Re: **Docket 433** – UIL Holdings Corporation Certificate of Environmental Compatibility and Public Need for the construction, maintenance, and operation of a 115/13.8 kilovolt substation located at 14 Old Stratford Road, Shelton, Connecticut – **Notification of Modification**

Pootatuck Substation Landscape Tree Removal Proposal

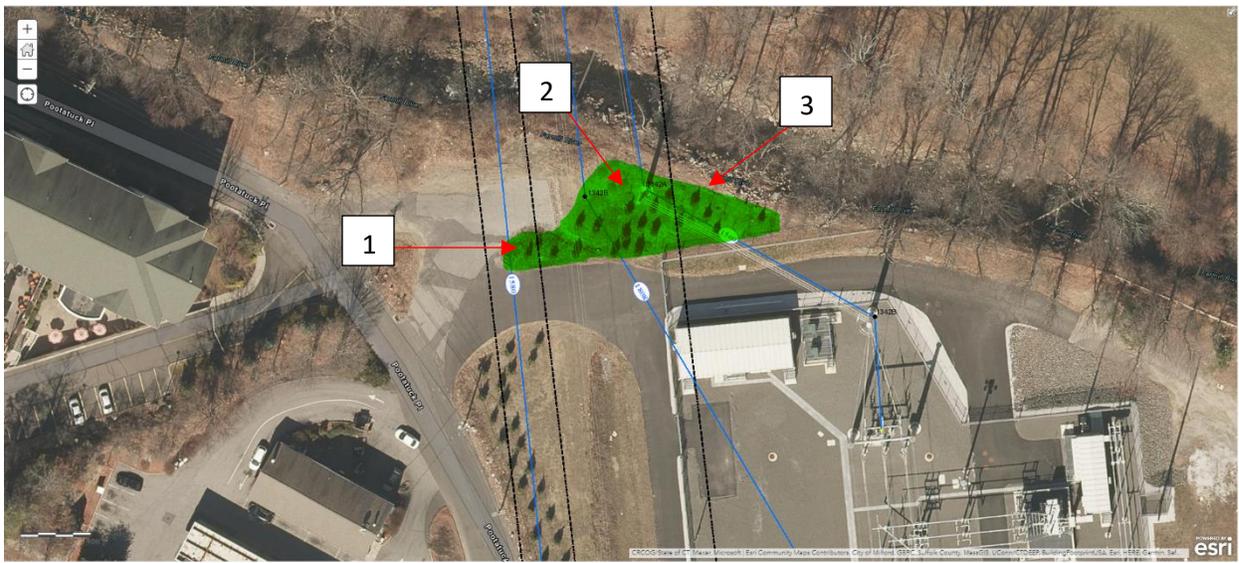
- 1) Remove three Mountbatten junipers at driveway edge. Evidence of illicit activity present at site and removal would open the sightline for local police and UI security.
- 2) Remove plantings around base of towers to provide 15' of space for inspection and maintenance.
- 3) Remove all landscaped plantings on north side of Pootatuck Substation. Kousa dogwoods are now considered an incompatible species. Additionally, the tight spacing of the landscape trees makes maintenance access difficult on foot going east along the northern perimeter fence and equipment access impossible. Low conductor height of the 1560 line drop into the substation is a noted concern for the access issue created by the landscape plantings.

SITE PLANTING PLAN		
SHELTON SUBSTATION		
CAD FILE NAME	SEQUENCE No.	DRAWING NUMBER
		XXXX-030

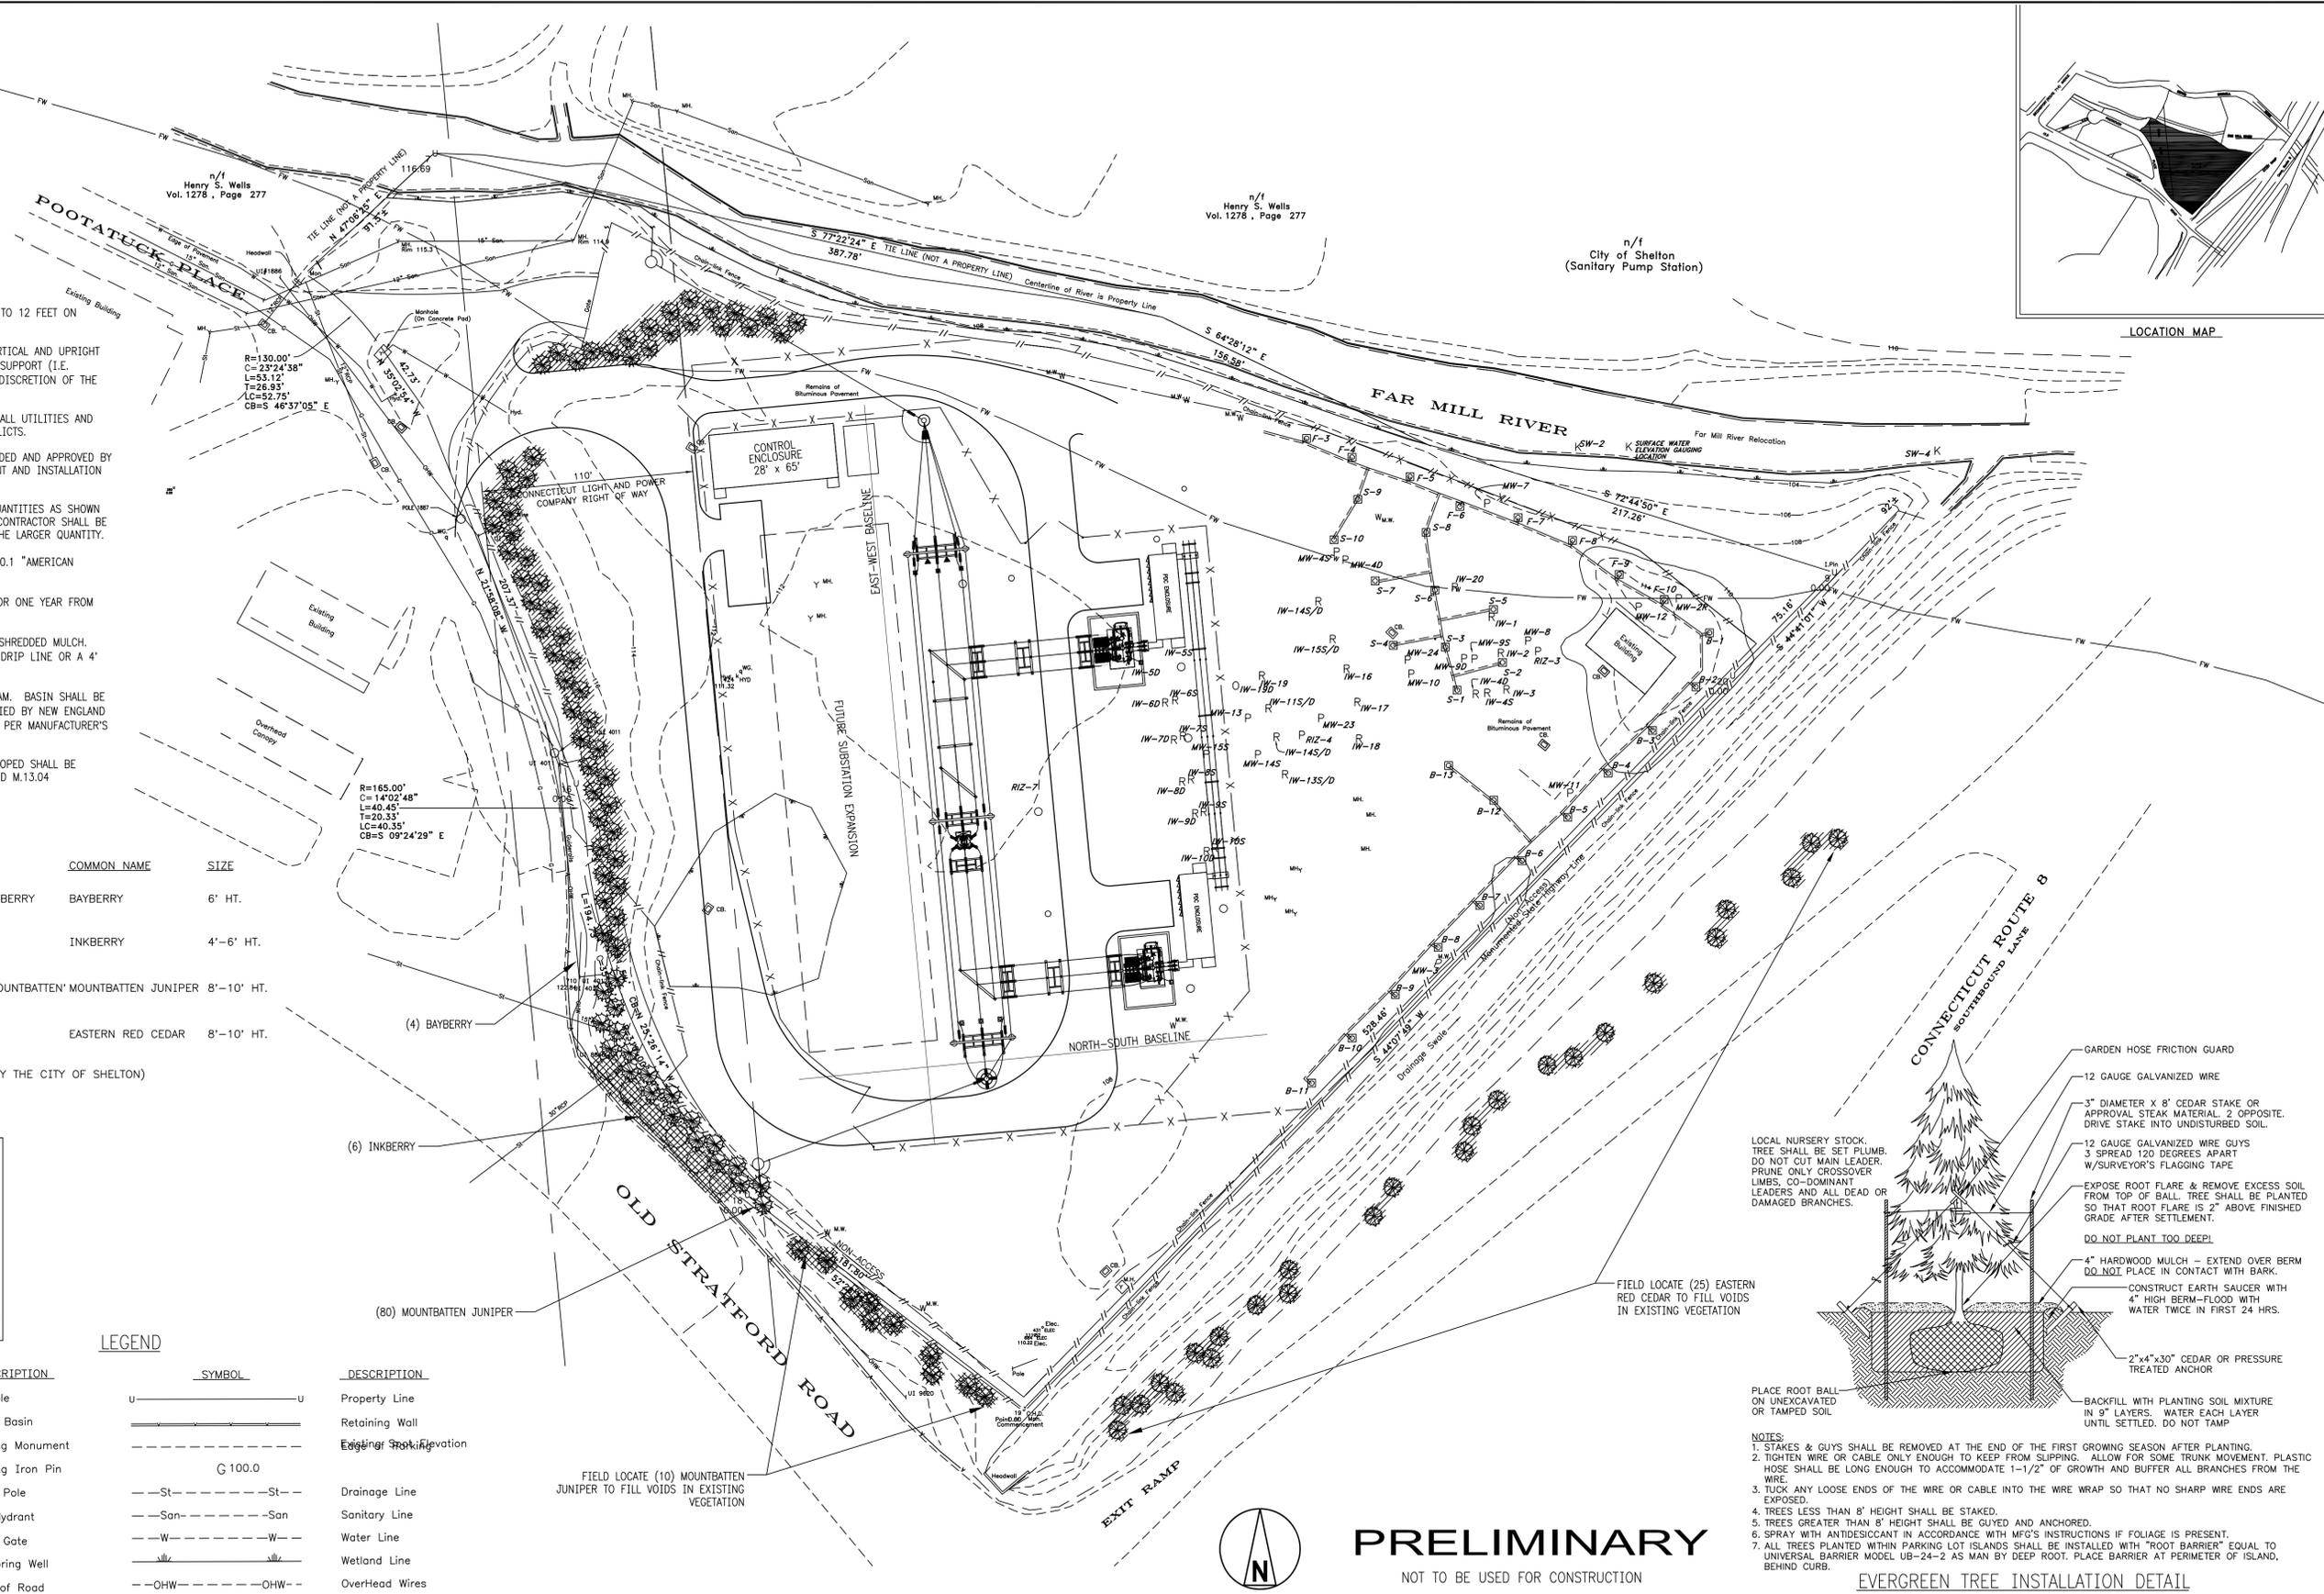
To accommodate new specifications for tree heights allowed in the Eversource ROW, Eversource has requested to remove all species within the ROW that do not meet the updated specifications. Eversource’s removal plan and planting drawing 030 from the approved D&M Plan are attached for the Council’s information.
